Docket Number:	17-BSTD-02
Project Title:	2019 Title 24, Part 6, Building Energy Efficiency Standards Rulemaking
TN #:	222823
Document Title:	Philips Lighting additional comments on NEMA 77
Description:	N/A
Filer:	System
Organization:	Philips/Kelly Seeger
Submitter Role:	Public
Submission Date:	3/2/2018 10:51:30 AM
Docketed Date:	3/2/2018

Philips Lighting additional comments on NEMA 77

Philips Lighting Additional Comments in Support of NEMA 77 as a Method for Qualifying Products to 2016 CA Title 24 JA8

Figure 2: SVM behavior during dimming of a typical A-lamp.

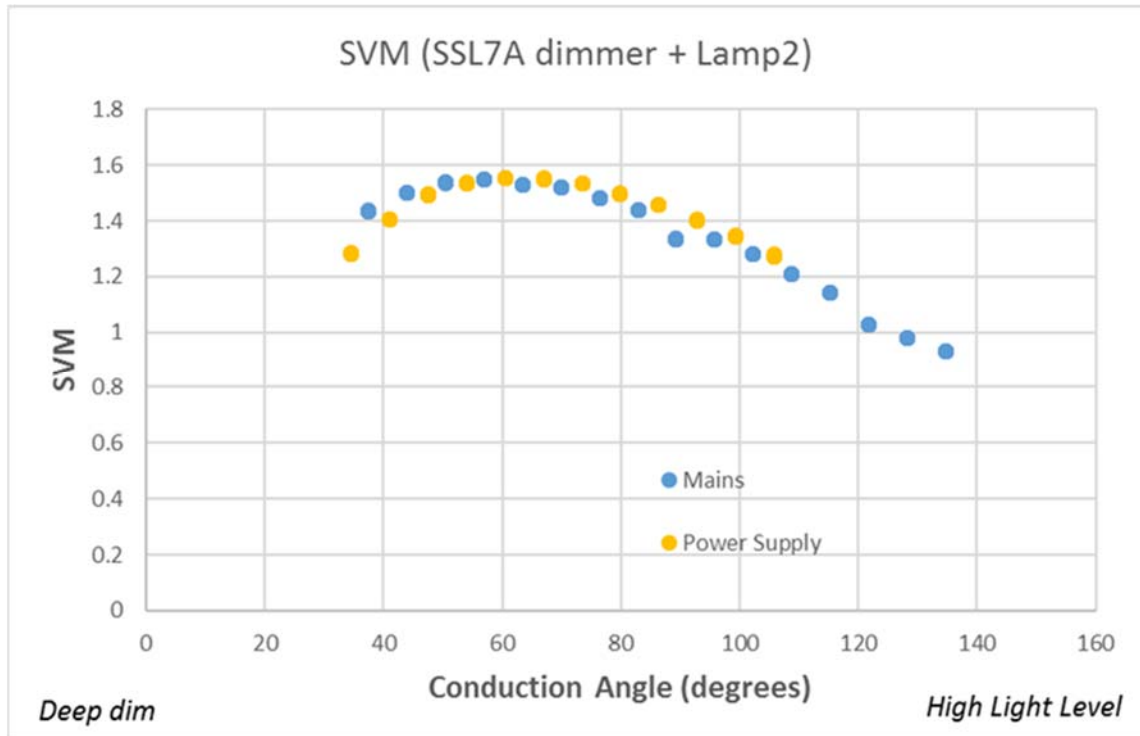
This product has the SVM behavior shown in Figure 2 below. The SVM of most LED sources will show similar increase during dimming. Although SVM is less than 1.0 at full light output (about 0.9 at full output on a dimmer and about 0.6 when operated without a dimmer), it has a peak SVM of nearly 1.6 when

dimmed. The eye is less sensitive to stroboscopic effect as light levels decrease [Perz, et al.]¹, so less strict limits on SVM may be set at lower light levels (e.g. SVM = 1.6). This product has been well accepted in the marketplace, however it would not be allowed in California if SVM = 1.0 becomes the requirement (the requirement applies both at 100% and 20%). Note that if the Slimstyle lamp was redesigned to have a peak SVM when dimmed of 1.0, then the SVM at full output on a dimmer (with ~140 degree conduction angle) would be <0.6. Redesigning to meet SVM = 1.0 over the entire dimming range would result in an SVM of 0.3 – 0.4 (with no dimmer). A universal specification of SVM = 1.0 forces overdesign and corresponding added cost that is simply not necessary for general illumination products.

This could make *dimnable* lamps unfavorable in the market place. Non-dimnable lamps could simply be designed for SVM = 1.0 (at full output) whereas dimmable lamps would have to be overdesigned to meet SVM = 0.3 – 0.4 at full output, thus dis-incentivizing the use of dimmable lamps.

Because stroboscopic effect is less visible during dimming, we recommend that the Title 24 JA8 requirements allow a higher SVM during dimming.

Figure 3: Comparison of TLA measures and conventional light sources.

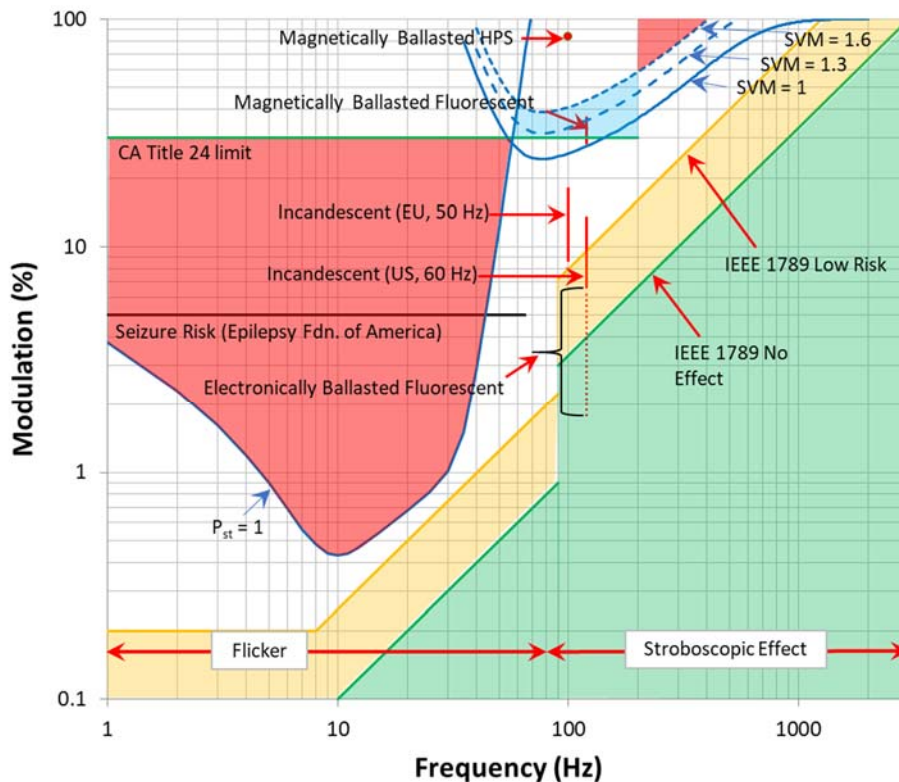
First, as stated above, there is no evidence that phantom array is more serious than stroboscopic effect or flicker. In fact, there is ample evidence that flicker⁴ is a trigger for photosensitive epilepsy and migraines, which the commenters should know but choose to ignore. NEMA 77 places much **stricter** limits on flicker in this area (large red region in Figure 3) than does Title 24 2016.

The commenters state that NEMA 77 does not describe the applications for which IEEE 1789 is too strict. Those applications are described in Figure 3, which clearly shows that if you rule out LED lamps with equivalent flicker to existing technologies (e.g. incandescent, HPS), you rule out their use in all applications that used those lamps in the past.
